UNITED STATES PATENT AND TRADEMARK OFFICE

APPLICATION NO.	FILING DATE	FIRST NAMED INVENTOR	ATTORNEY DOCKET NO.	CONFIRMATION NO.
09/473,450	12/28/1999	SEOK HYUN YUN	5204-10	9993

Office Action Summary

DETAILED ACTION

FIG. 3

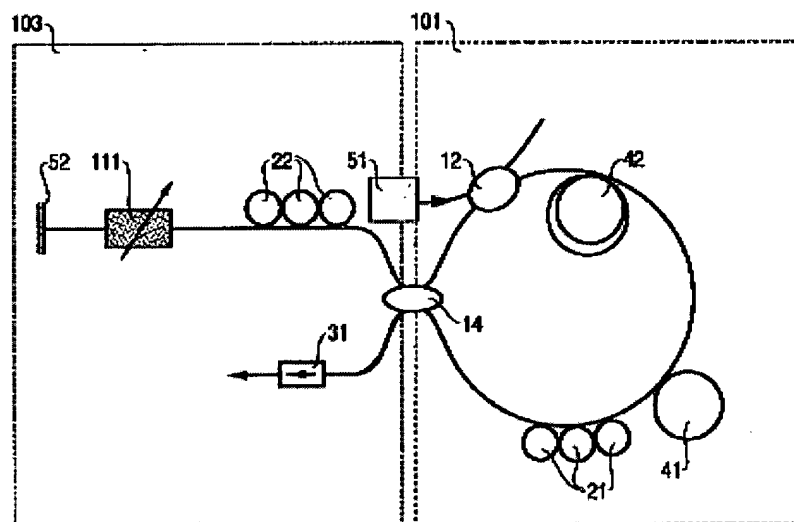
Claims 1,2,4-22 rejected under 35 U.S.C. 102(e) as being anticipated by Jeon et al (PN 5,812,567).

Figure 3 illustrates a wavelength tunable mode-locking optical fiber laser having a pump source (51), a wavelength division coupler (WDM) (12), an erbium doped gain medium (42) column 2 line 63, a dispersion shifted fiber (41) which allows for nonlinear effect column 3 line 1, polarization controllers (21) and (22), an acousto-optic tunable filter (111) for changing the wavelength, abstract, and a Faraday rotator for controlling the direction of polarization of the beam, abstract. Where the system as illustrated with an amplifying loop (101) and linear mirror (103) combined provide mode-locking of short pulses, column 4 line 40 and the abstract.
